LINCOLN PARK PLANNING COMMISSION

November 10, 2021 at 7 p.m.

Site Plan Review

Site Plan Review

PROPOSED SITE PLAN

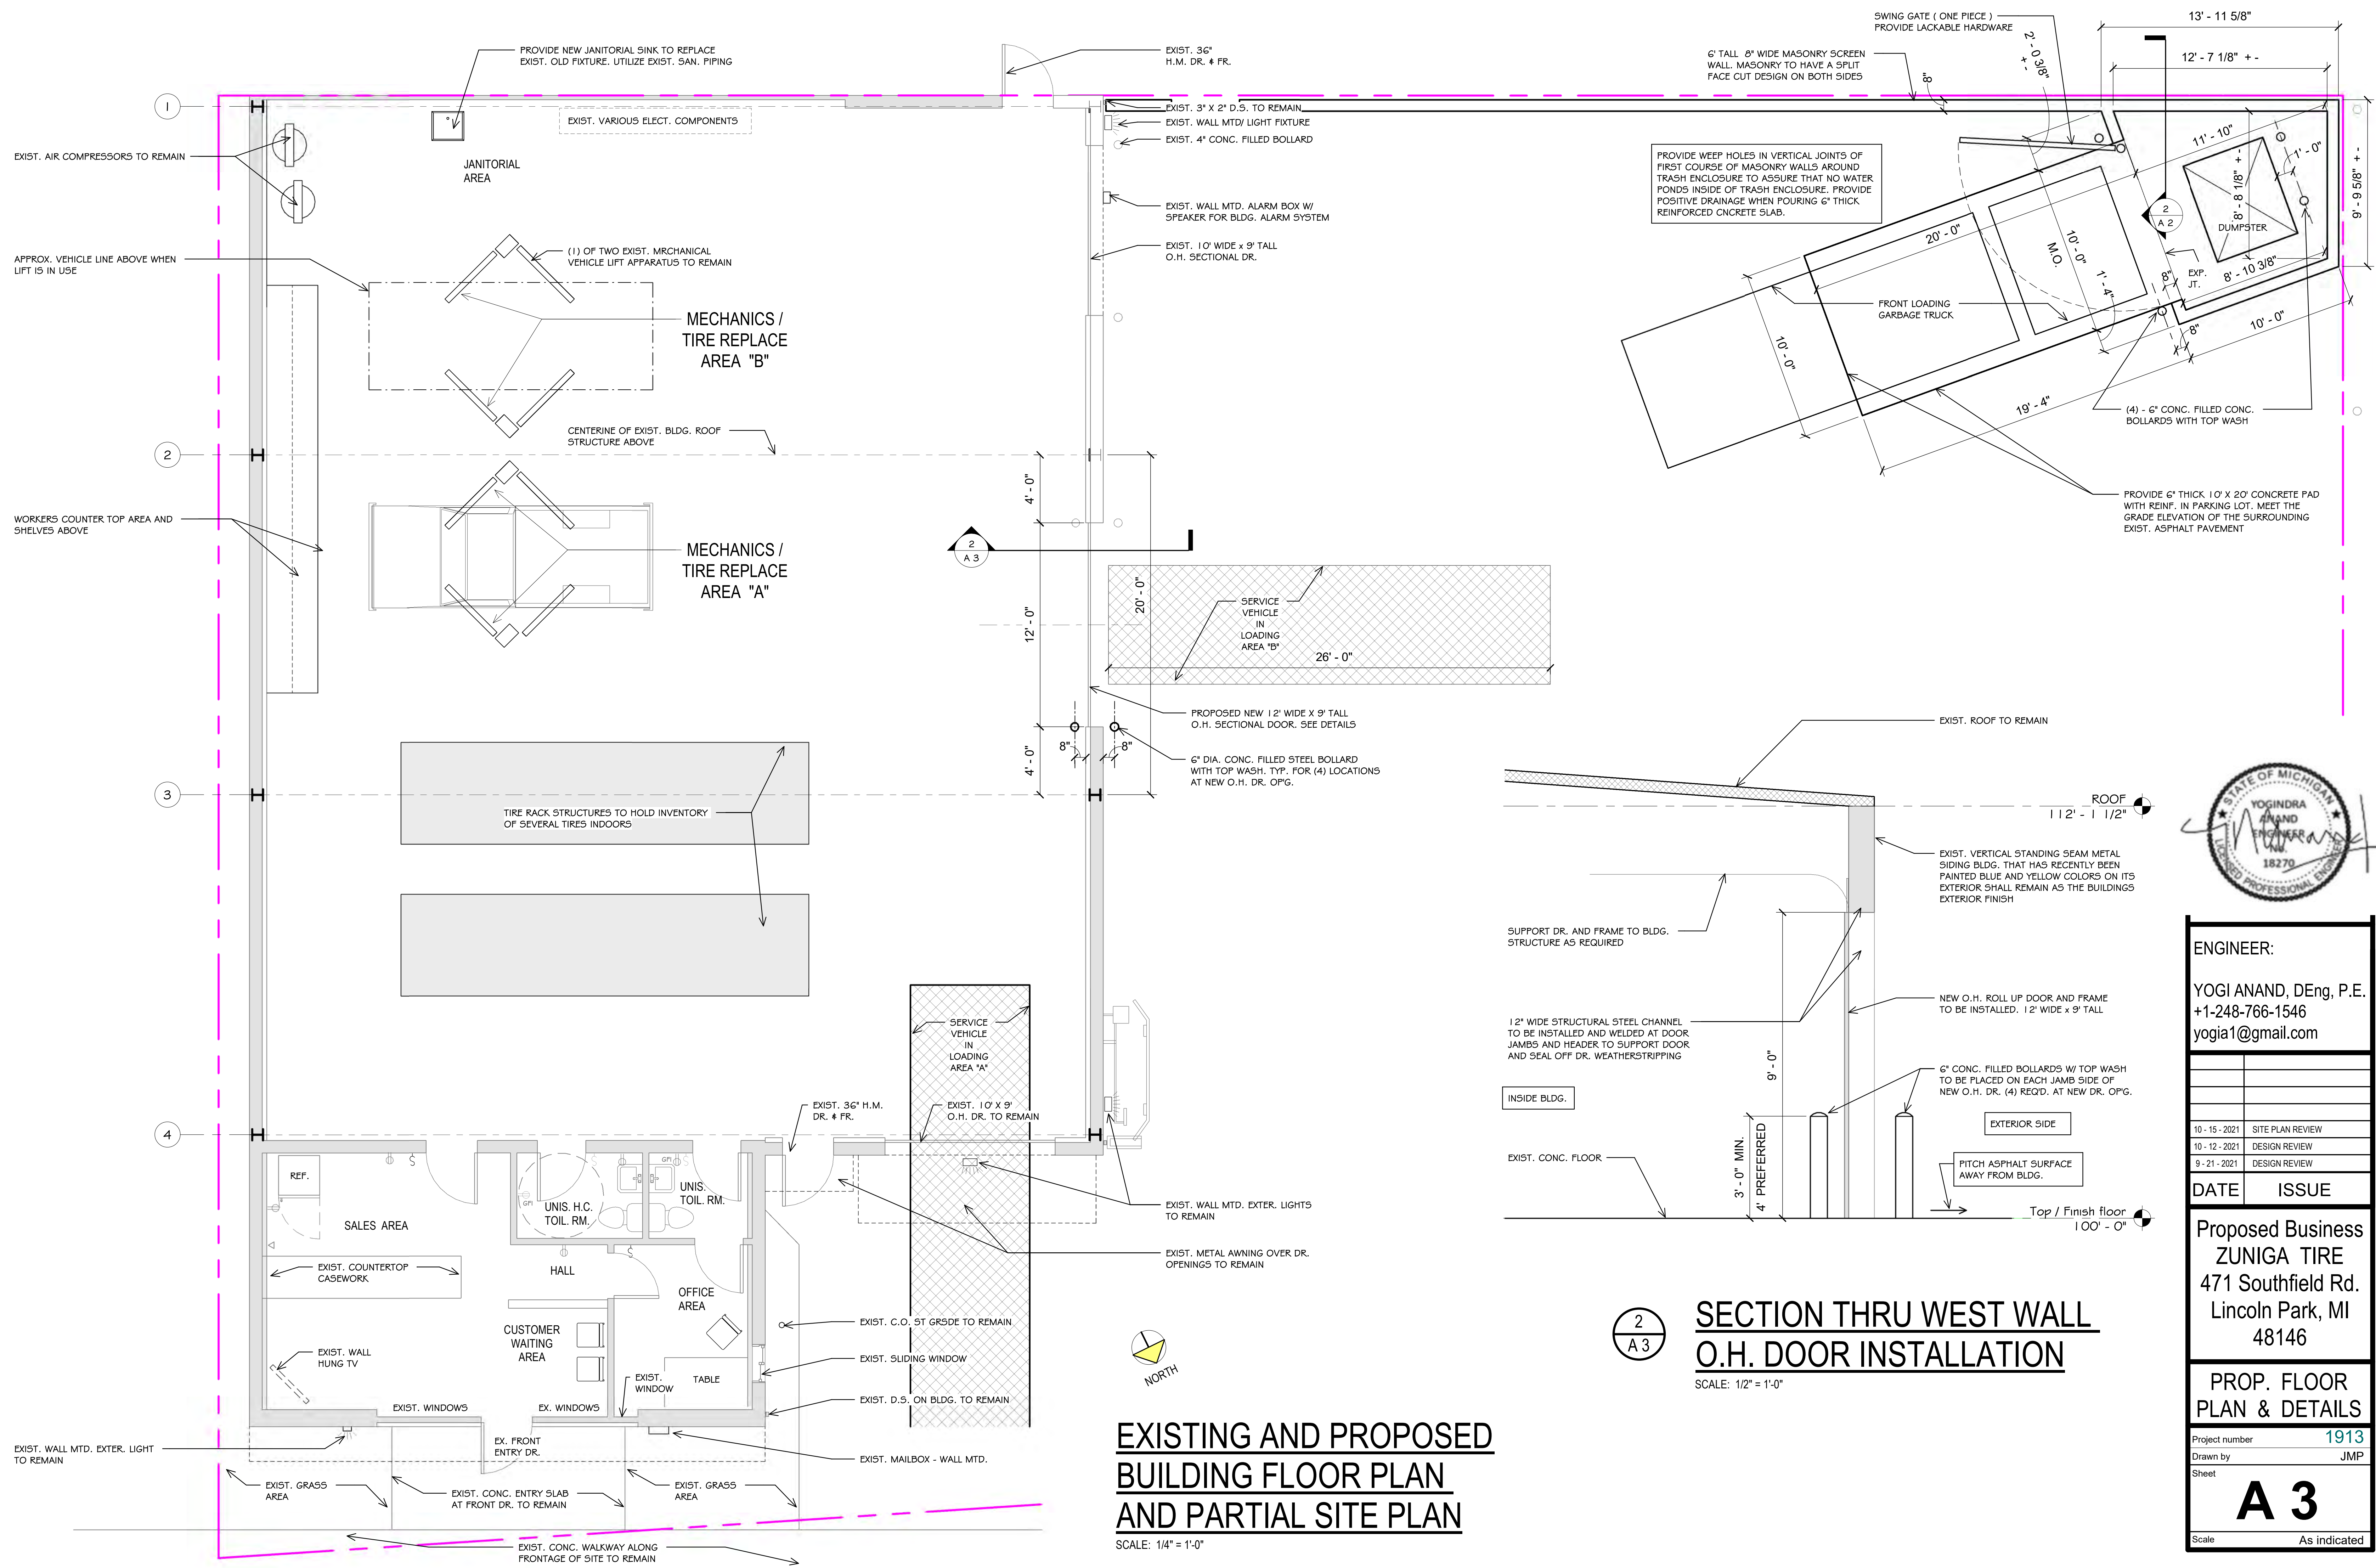
Required	Proposed	Compliance
Parking Area Type B §1290.05	Adequate means of ingress and egress shall be provided and shown	Existing ingress and egress on Southfield Rd. Existing concrete is in poor condition and will be replaced in 2022.	Met
	Parking facilities, access drives, and maneuvering aisles shall be hard surfaced with concrete or plant-mixed bituminous material, maintained in a usable dustproof condition and graded and drained appropriately	Parking area is covered with asphalt, which will be replaced.	Met
	Concrete curbs and gutters	Concrete curbs and gutter are indicated on the site plan. Details will be provided at the time of detailed Engineering review.	Met
	When adjoining residential property and/or a residential street or alley: 6' solid masonry wall, ornamental on both sides, with bumper guards	6' solid masonry wall proposed on rear end of property adjoining a residential alley.	Met

- Applicant shall provide curb and gutter details at the time of Detailed Engineering Review.
- Applicant shall replace any broken and cracked asphalt in the existing parking area.
- Applicant shall provide curbs along landscaped areas and indicate such curbs on the plan.

EXTERIOR BLDG
ELEVATIONS

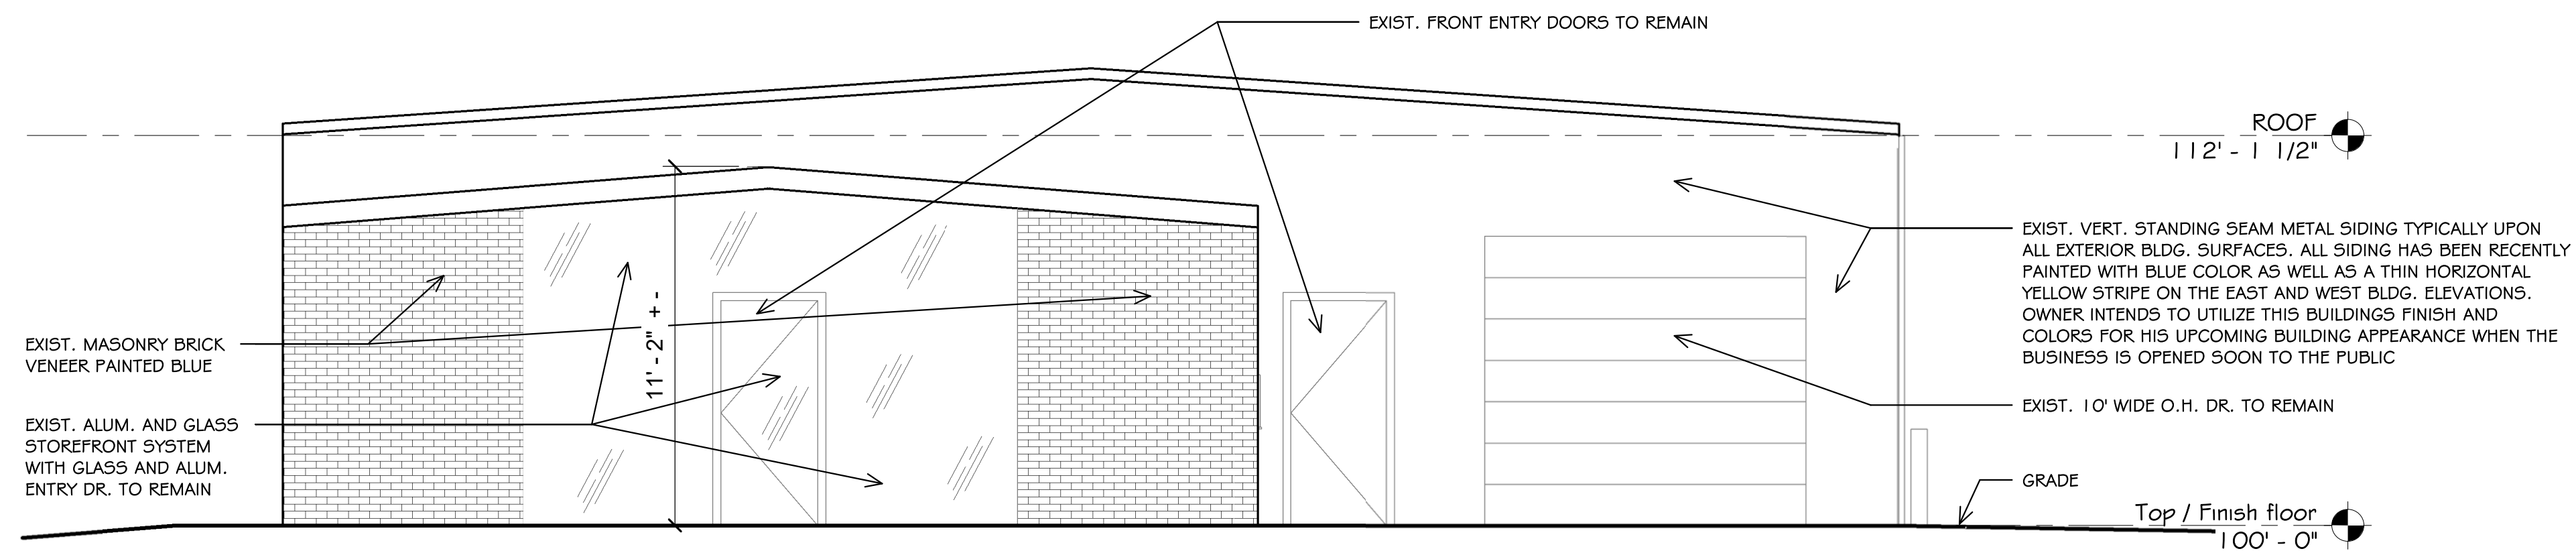
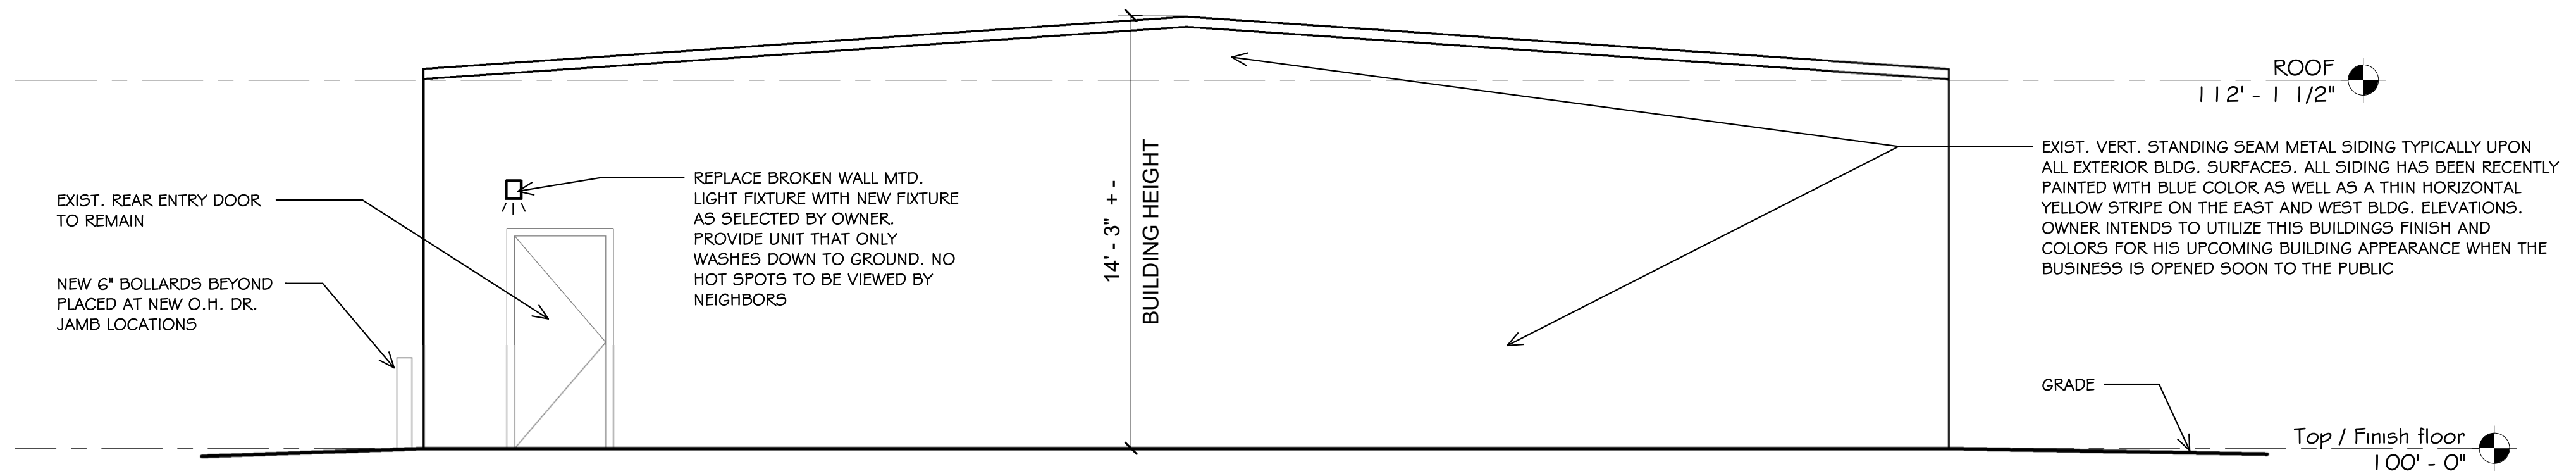
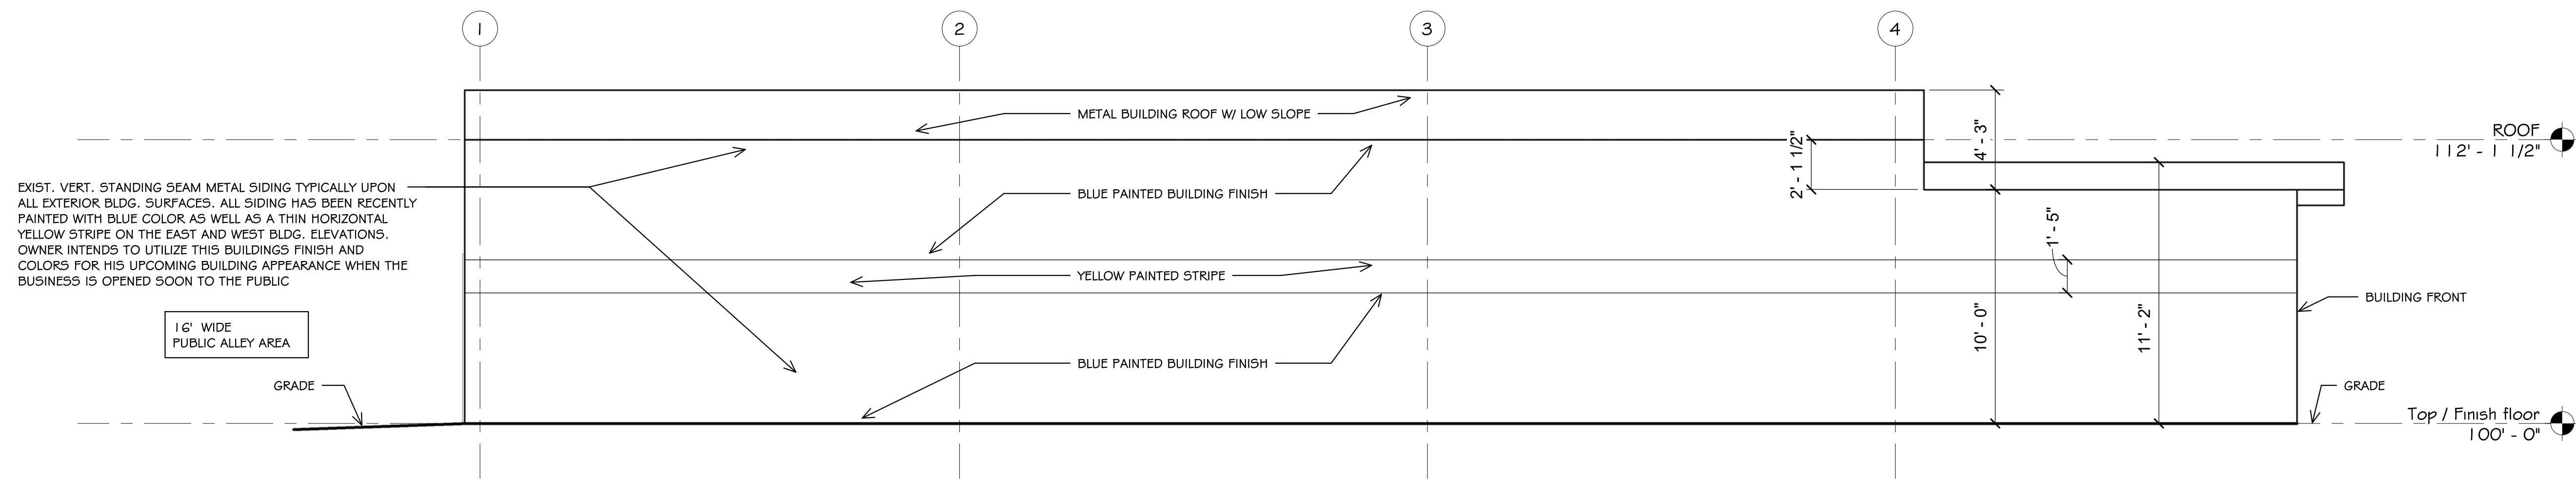
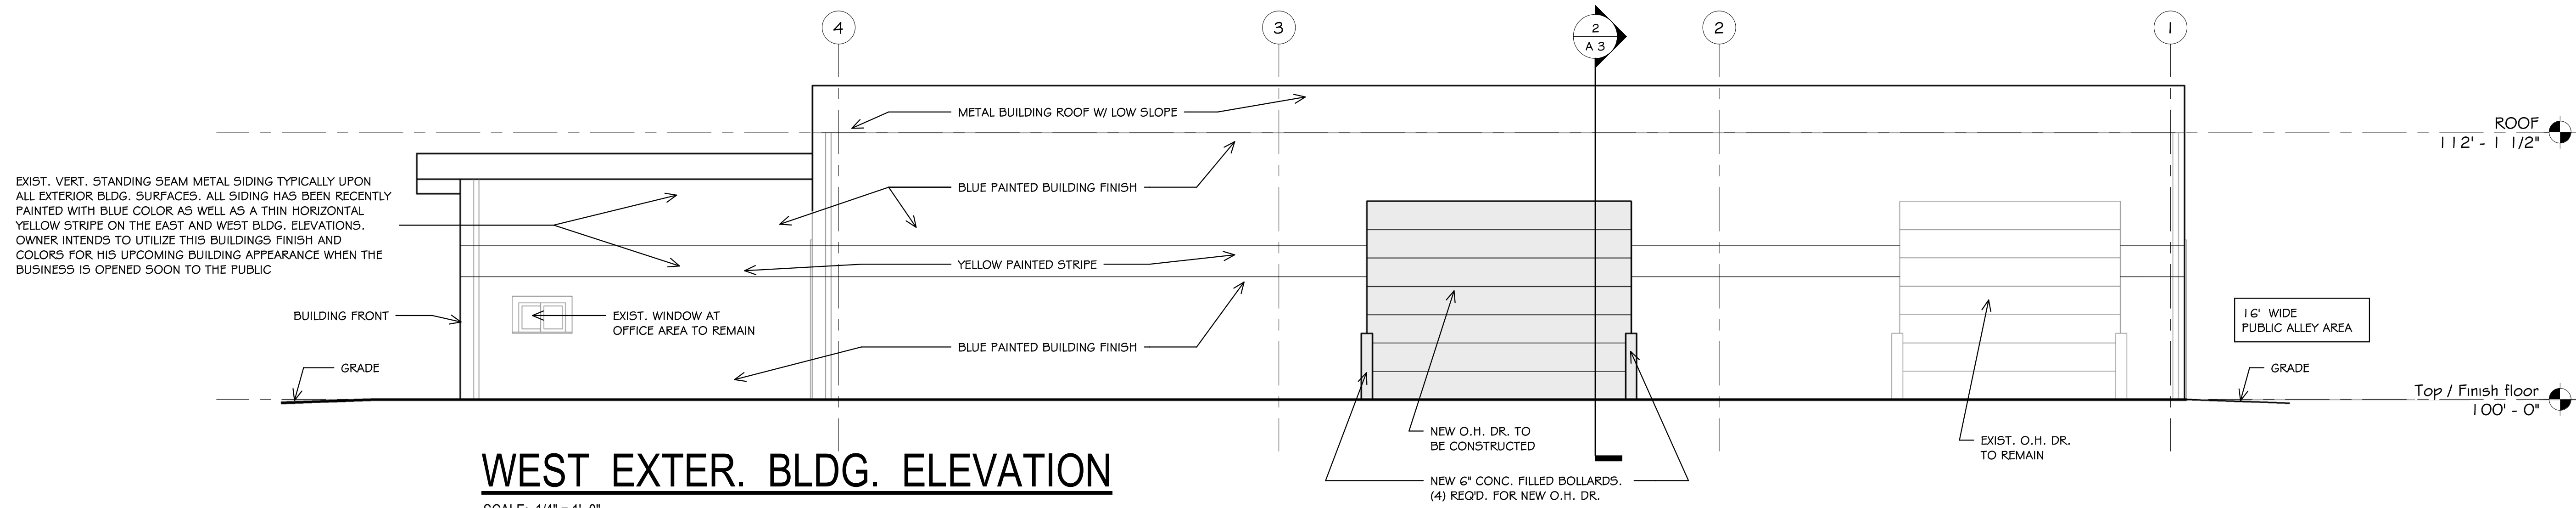
Required	Compliance
<ul style="list-style-type: none"> • Building mass, height, bulk and width-to-height ratio within 50-150% of buildings within 500' 	<p>Met</p>
<ul style="list-style-type: none"> • Architectural variety • Similar materials and entrances to buildings within 500'  <p>Figure 3: Southfield Rd looking east</p>  <p>Figure 4: Southfield Rd looking west</p>	<p>Met</p>
<ul style="list-style-type: none"> • Building materials: primarily natural products conveying permanence (brick, decorative masonry block, stone, or beveled wood siding) = 75% of each façade (industrial districts, 50% if facing ROW) <u>North Elevation (front): 0% masonry</u> <ul style="list-style-type: none"> ○ Painted Brick Veneer: ~143 sf ○ Metal Siding: ~257 sf ○ Metal Doors: ~115 sf ○ Glass Windows & Doors (exempt): ~156 sf ○ Total Area: ~671 sf <u>South Elevation (rear): 0% masonry</u> <ul style="list-style-type: none"> ○ Metal Siding: ~645 sf ○ Metal Doors: ~26 sf ○ Total Area: ~671 sf <u>East Elevation (side): 0% masonry</u> <ul style="list-style-type: none"> ○ Metal Siding: ~1,070 sf ○ Total Area: ~1,070 sf <u>West Elevation (side): 0% masonry</u> <ul style="list-style-type: none"> ○ Metal Siding: ~869 sf ○ Metal Doors: ~197 sf ○ Glass Window (exempt): ~4 sf ○ Total Area: ~1,070 sf • 25% may be glass, exterior insulation finish systems (EIFS), vinyl, aluminum, or steel siding; or similar synthetic or highly reflective materials (industrial districts not facing public streets or freeways, these and pre-cast concrete or plain masonry block) 	<p>NOT MET</p>
